**GEOPHYSICAL INVESTIGATION  
OF THE  
SUSPECTED DRUM BURIAL AREA**

**Camp Bonneville  
Vancouver, Washington**

**FINAL  
SUMMARY REPORT  
GEOPHYSICAL INVESTIGATION OF CAMP BONNEVILLE  
SUSPECTED DRUM BURIAL SITE**

## DESIGN REVIEW COMMENTS

Figure 2

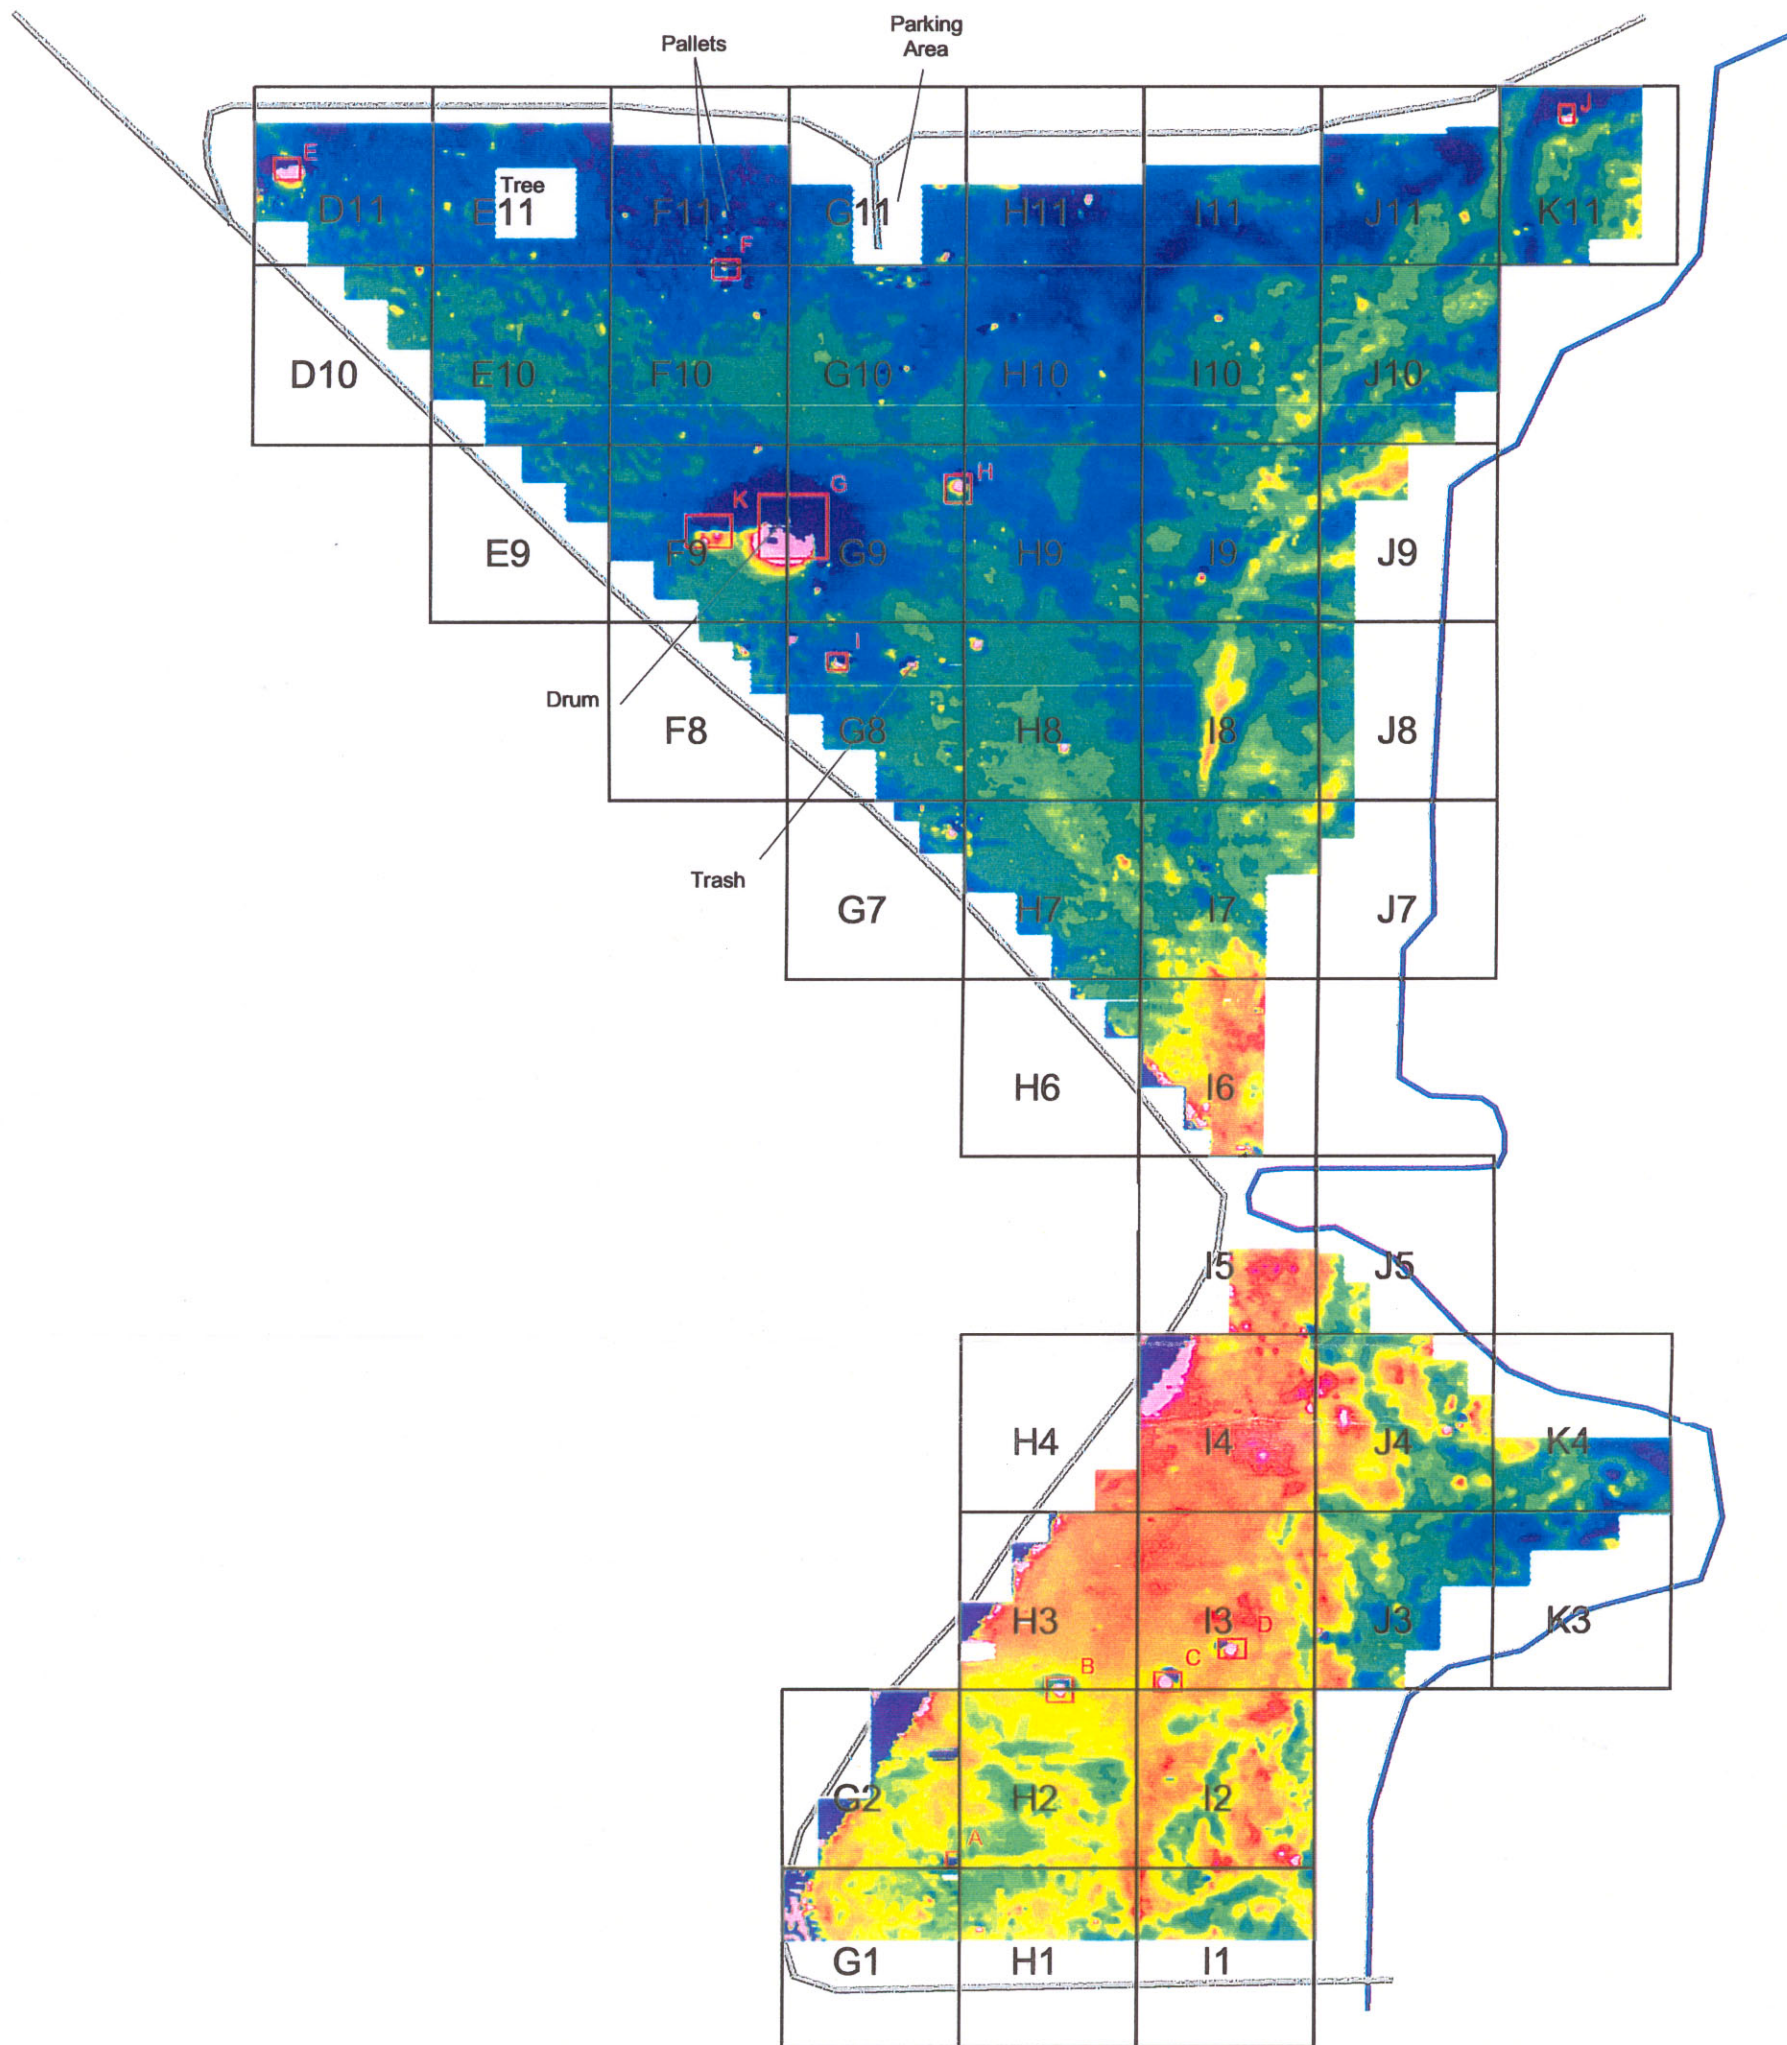
ITEM	DRAWING NO. OR REFERENCE	COMMENT	ACTION
1.		The data and picked targets are acceptable. There are other smaller dipole anomalies in the area. Are these too small to possibly be drums which are deeply buried?	The magnetic anomalies created by buried drums are expected to be at least 10 to 15 feet across or larger depending on the number of drums. As the drums are buried deeper, the anomalies are lower in amplitude but still a large area. At the lowest amplitudes, the area of the anomaly may be difficult to distinguish. High amplitude anomalies with small areas are expected to be caused by smaller metal objects. Of course, this interpretation assumes relatively intact drums.
